**CITY OF FORT COLLINS
TYPE 1 ADMINISTRATIVE HEARING
FINDINGS AND DECISION**

PROJECT NAME: Centre for Advanced Technology 23rd Lot 2 Office Building

CASE NUMBER: FDP150007

ELECTRICAL PHOTOMETRIC PLAN
SCALE: 1" = 20'

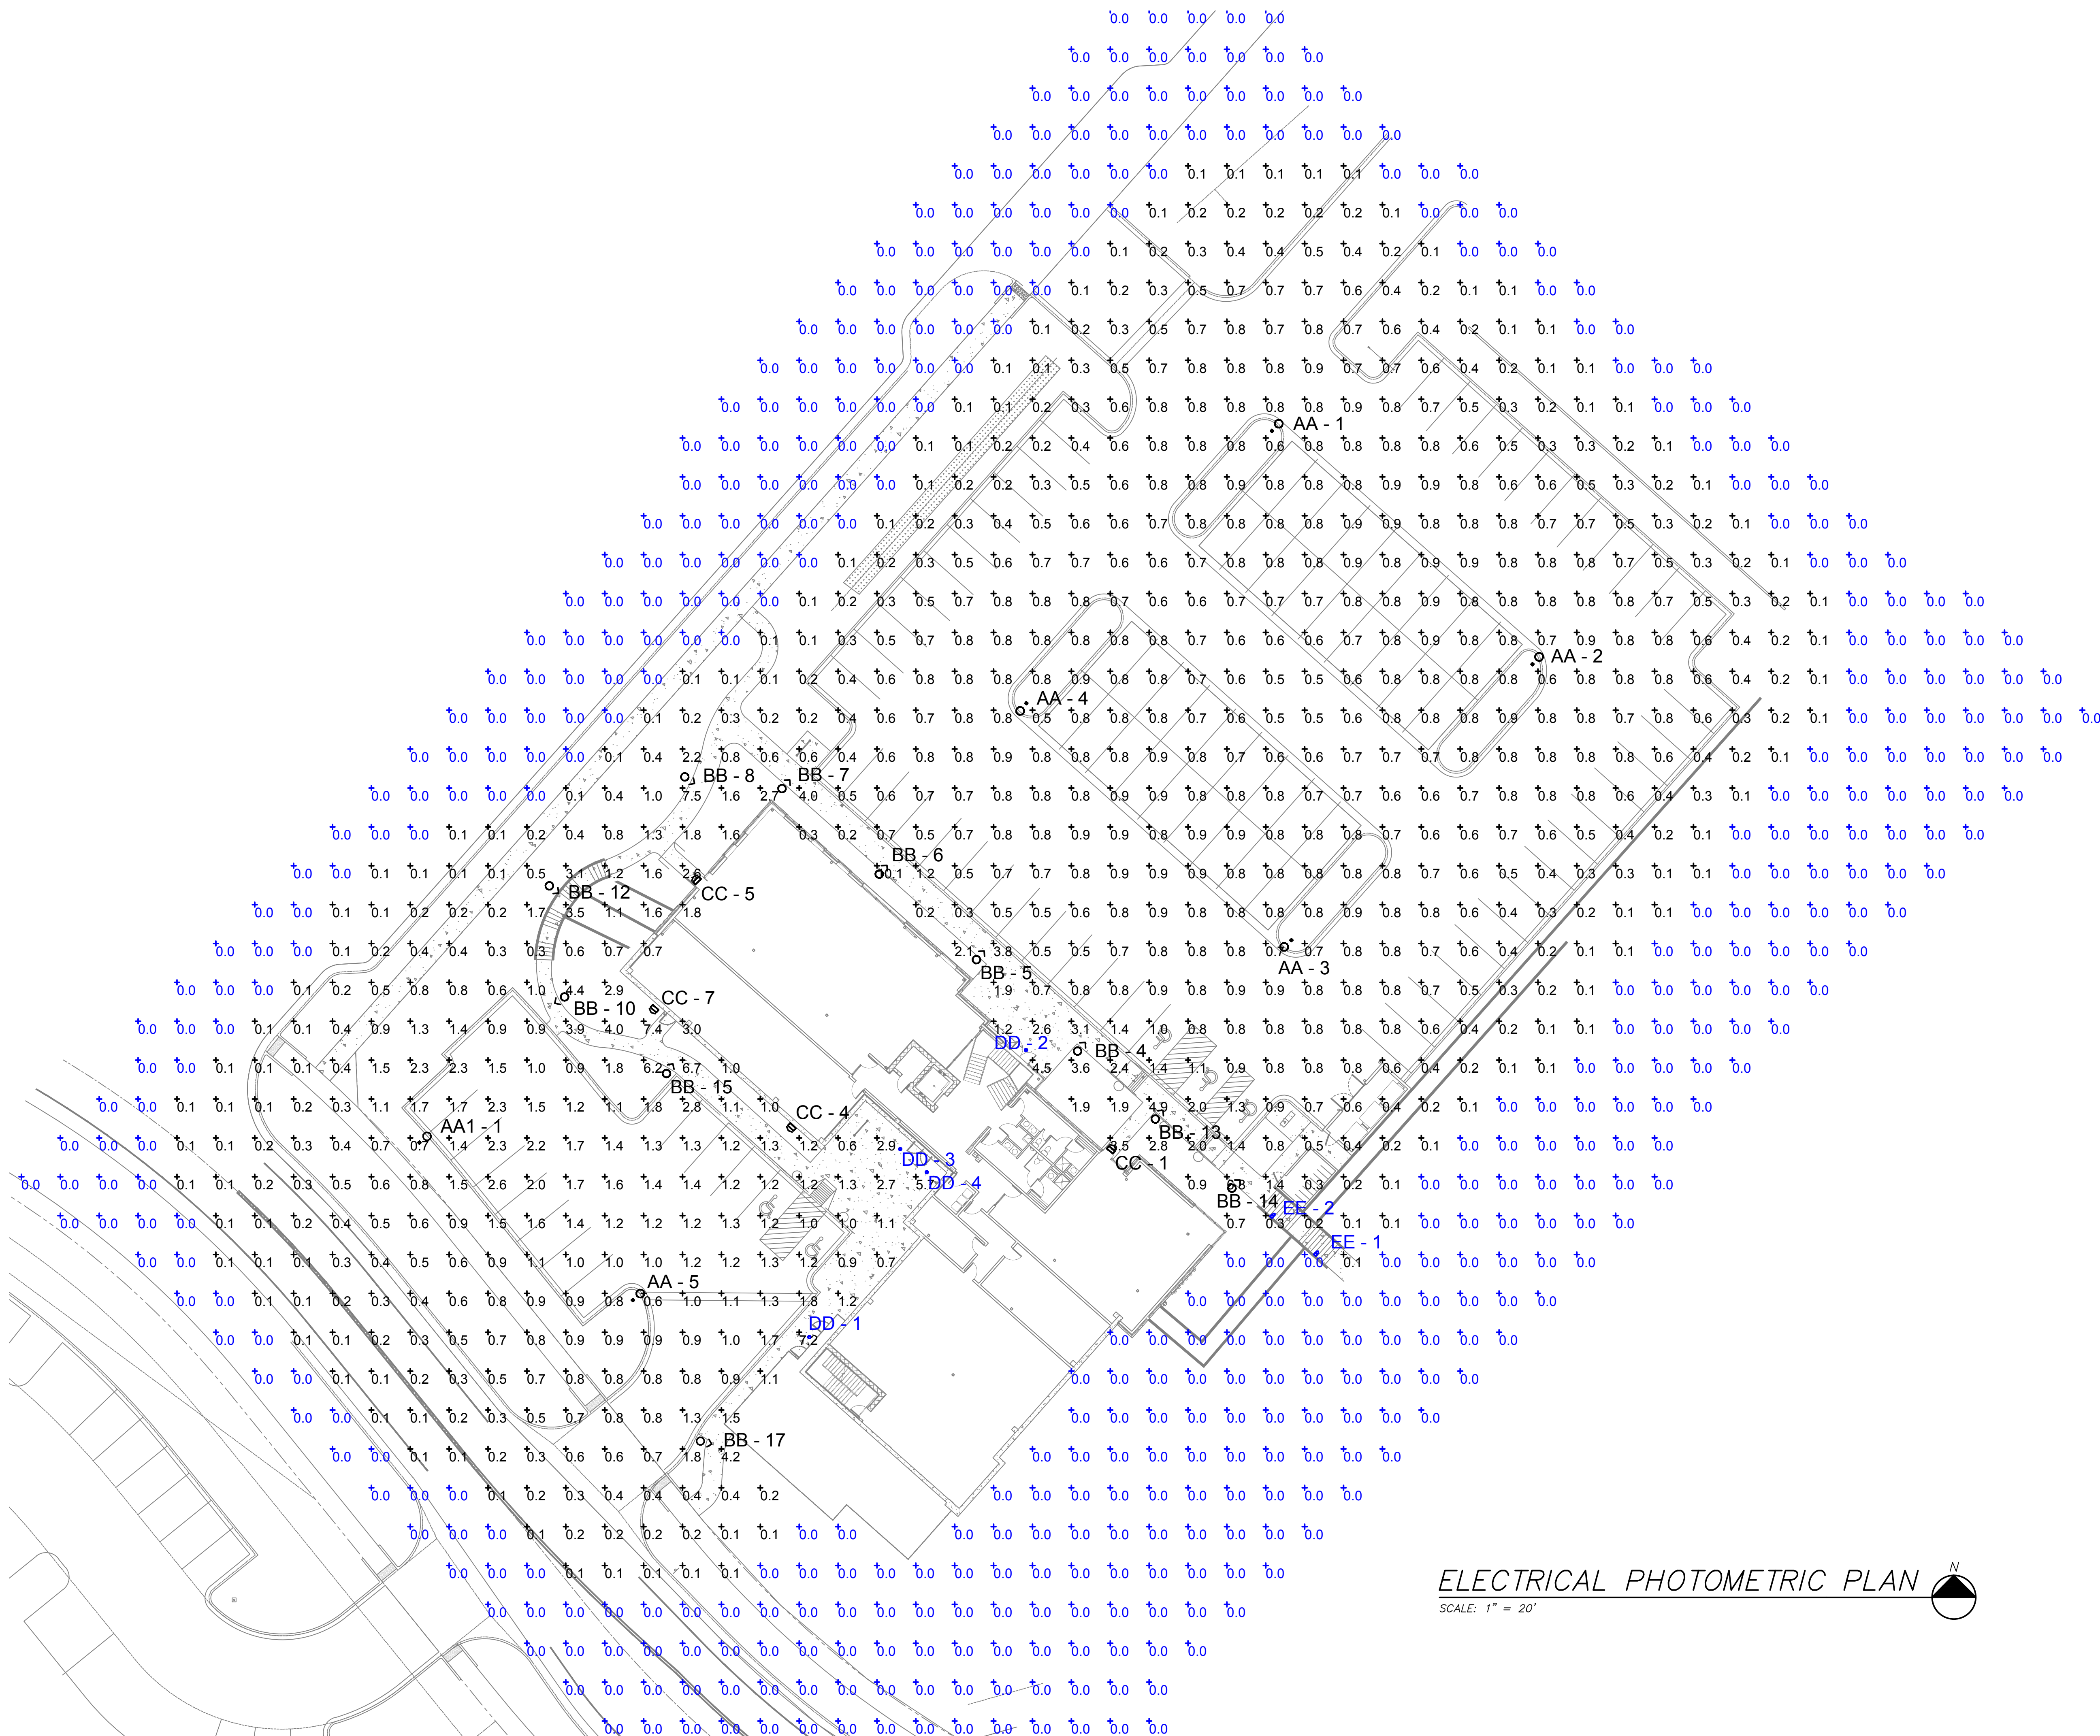
The proposed lighting plan is consistent with the requirements of the Land Use Code in regards to the general standard, lighting levels and design standards.
